FILE P. I. No. 0006699, Columbia County
CSMLS-0006-00(699)
SR 402/I-20 Noise Barriers West of
SR 383/Belair Road

SUBJECT APPROVED REVISED PROJECT CONCEPT REPORT

SUBJECT **Revised Project Concept Report**

REVISED PROJECT CONCEPT REPORT

TYPICAL SECTIONS

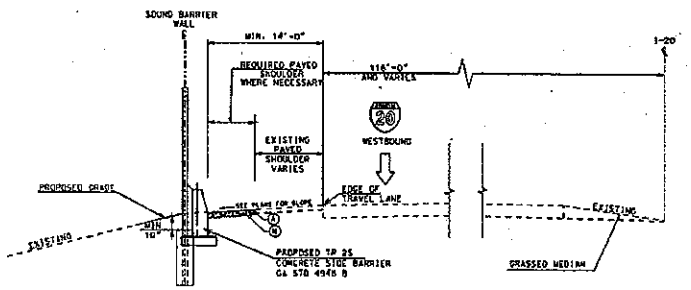
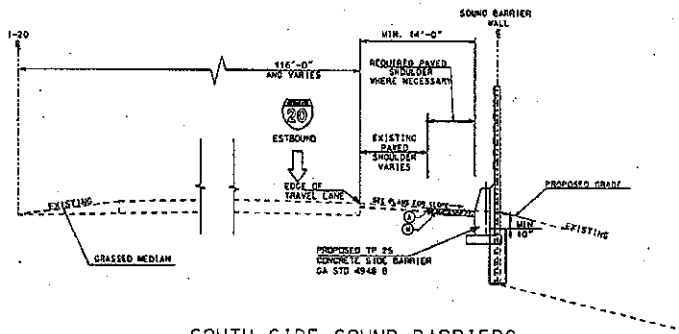
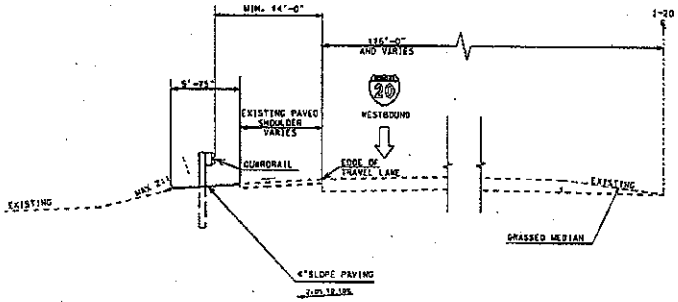
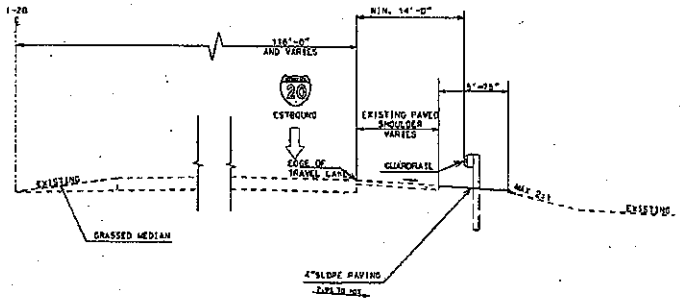
- The typical section is a 14' paved shoulder with guardrail, v-gutter, and noise barrier offset 5' behind guardrail.
- Project termini are from State Route BMP (beginning mile post) 14.19 or STA 765+00 to State Route EMP (end mile post) 15.67 or STA 843+00.
- Congressional District in the approved concept report is 9.

- The revised typical section is a 14' paved shoulder with TP 2S concrete side barrier throughout the project and noise barrier wall offset 1' behind the TP 2S concrete barrier. This decision was made to minimize maintenance. The cost estimate has been revised also accordingly.
